SERVICE BULLETIN

REFERENCE _____
NUMBER 009
DATE 03-11-88
MODEL MR2 (AW),
Corolla (AE)

A240 B2 DISC AND PLATE MODIFICATION TO REDUCE SHIFT SHOCK

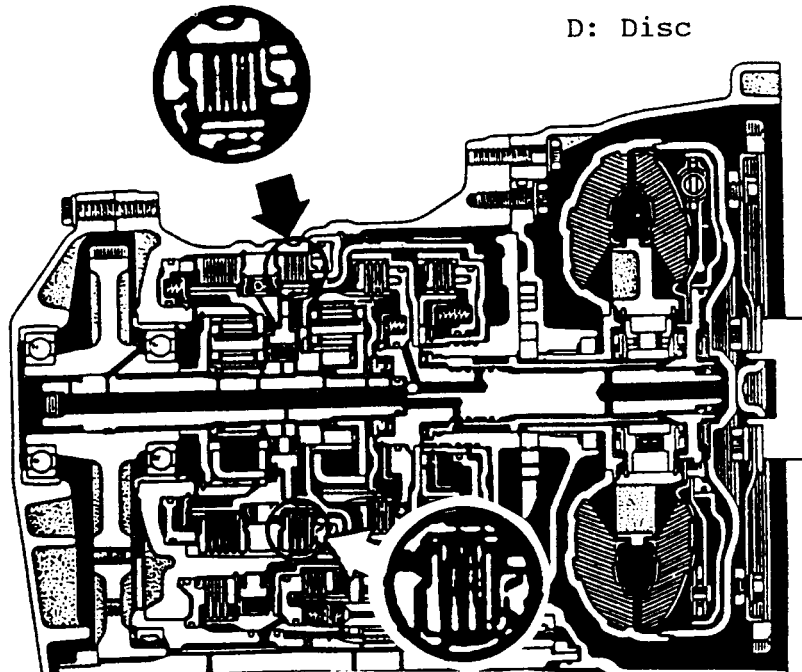
1. Friction material of B2 disc has been changed.
2. The number and order of B2 disc and plates has been changed. (See illustration)
3. B2 Accumulator Piston Spring has been changed.

PREVIOUS

disc	3 pieces
	plate	3 pieces

NEW

disc	2 pieces
	plate	4 pieces
